**AGENDA  
CITY OF CEDAR FALLS, IOWA  
PLANNING AND ZONING COMMISSION MEETING  
WEDNESDAY, AUGUST 25, 2021  
5:30 PM AT CITY HALL AND VIA VIDEO CONFERENCE**

**TO:** Planning & Zoning Commission  
**FROM:** Thom Weintraut, AICP, Planner III  
**DATE:** August 18, 2021  
**SUBJECT:** Land Use Map Amendment (LU20-04)  
 Rezoning Thunder Ridge, West 1<sup>st</sup> Street and Eagle Ridge Road (RZ20-009)

**TO:** Planning and Zoning Commission  
**FROM:** Michelle Pezley, Planner III  
**DATE:** August 17, 2021  
**SUBJECT:** Rezoning Request – 515 W. 2<sup>nd</sup> Street and 523 W. 2<sup>nd</sup> Street

**TO:** Planning and Zoning Commission  
**FROM:** Jaydevsinh Atodaria (JD), City Planner I  
 Luke Andreasen, PE, Principal Engineer  
**DATE:** August 17, 2021  
**SUBJECT:** MU Site Plan for Bluebell Health Plaza OBGYN addition (SP21 – 011)

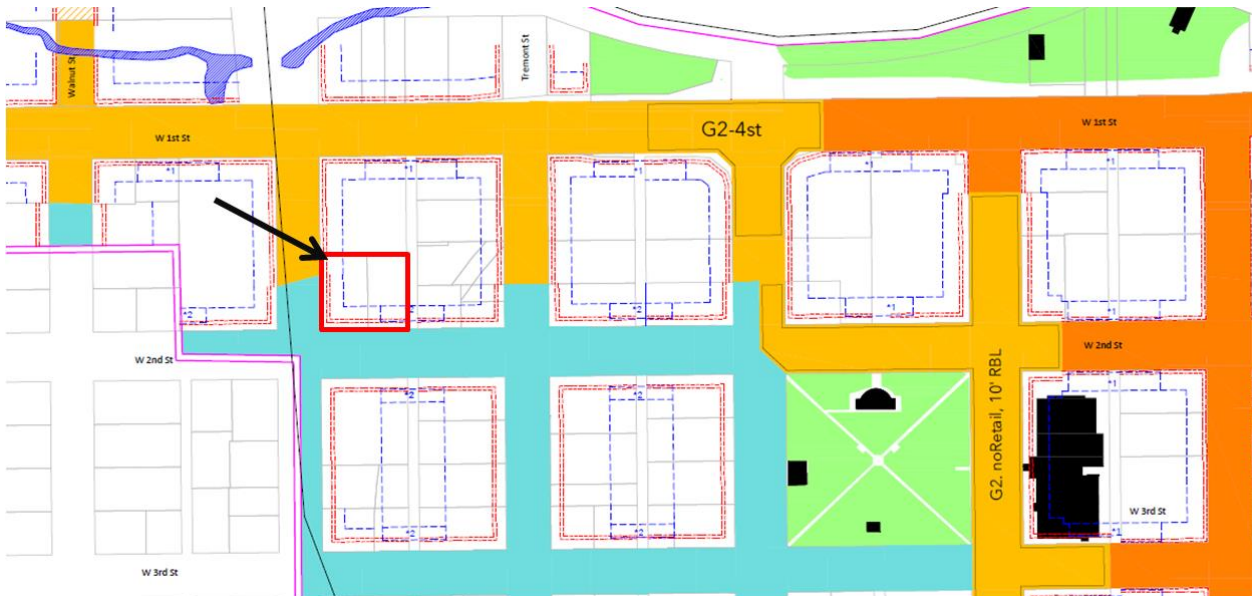
It should be noted that in response to concerns that commercial development needs more space, the area intended for more intense commercial and mixed use development is shown in the Vision Plan extending further toward 2<sup>nd</sup> Street than the current C-2 zoning.

In summary, an amendment to the *Imagine Downtown! Vision Plan* would be necessary in order to approve the requested rezoning. For all the reasons stated above, staff recommends against making any change to the plan. Since the plan was just recently adopted with considerable public input, any changes would warrant broader discussion of the various stakeholders in the downtown area.

**Building Height:**

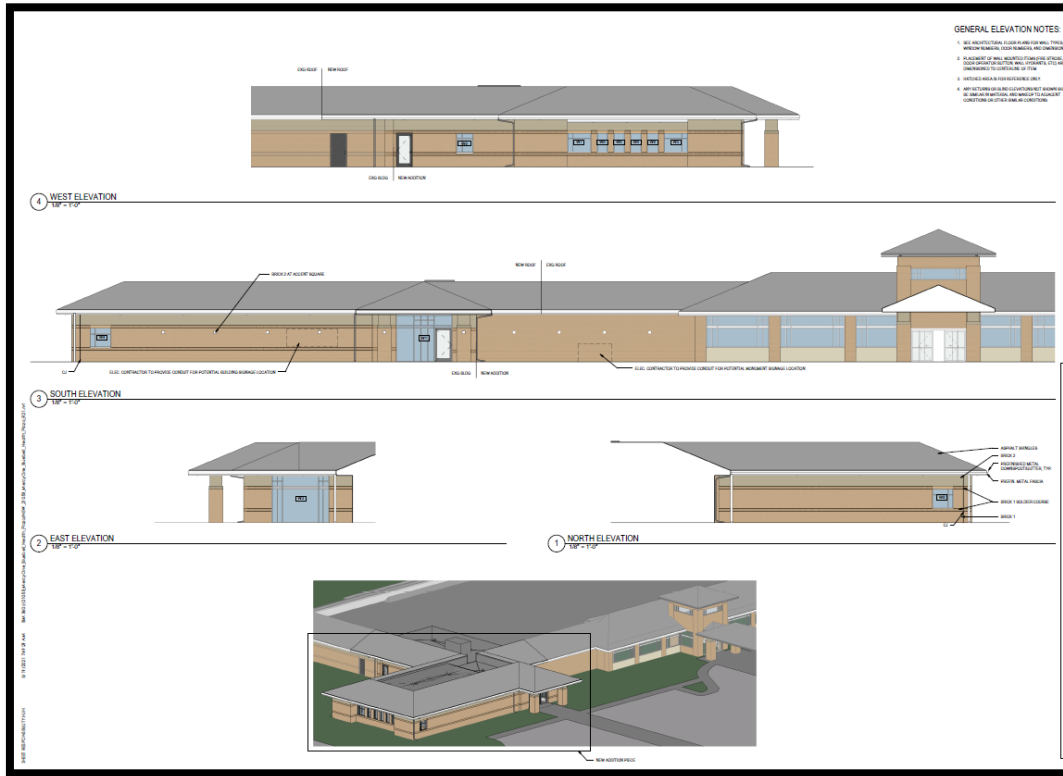
The maximum building height allowed in this district is 35 feet or three stories, whichever is less. The proposed building addition will be one story in height and will match the height of the existing building. The proposed building addition will expand the existing building in the south-west direction. **Building height satisfied.**

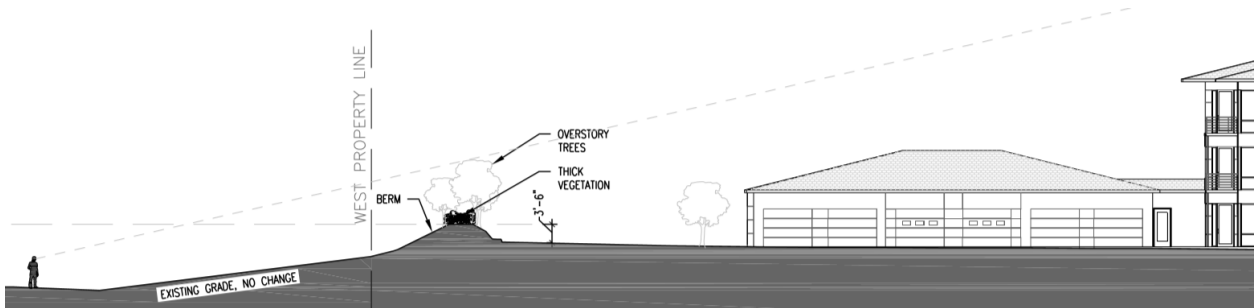
1. Below is a table of the spatial requirements that would apply to this project along with the proposed figures (including C-1 requirements for comparison):

<u>Required in C-1</u>	<u>Required in R-P</u>	<u>Proposed</u>
<b>Front Yard Setback:</b>	25 Feet	20 feet	34 feet (closest building); 55 feet (furthest building)
<b>Rear Yard Setback:</b>	10 feet	35 feet	69 feet (closest building); 90 feet (furthest building)
<b>Side Yard Setback:</b>	None	10 feet (25 feet total of both sides)	25 feet on north and 60 feet on south
<b>Lot area minimum:</b>	None	14,800 square feet per 12-plex	46,391 square feet per 12-plex
<b>Height:</b>	2 stories; 35 feet	N/A	3 stories; 42 feet

While the above figures are minimum requirements, the placement, design and height of the buildings will have to be substantially consistent with what is shown on the submitted master plan and outlined in the development procedures agreement. The setbacks, density and building height of the proposed development are listed in the column on the right. When a site plan application is submitted, it will need to be substantially consistent with these dimensional standards.
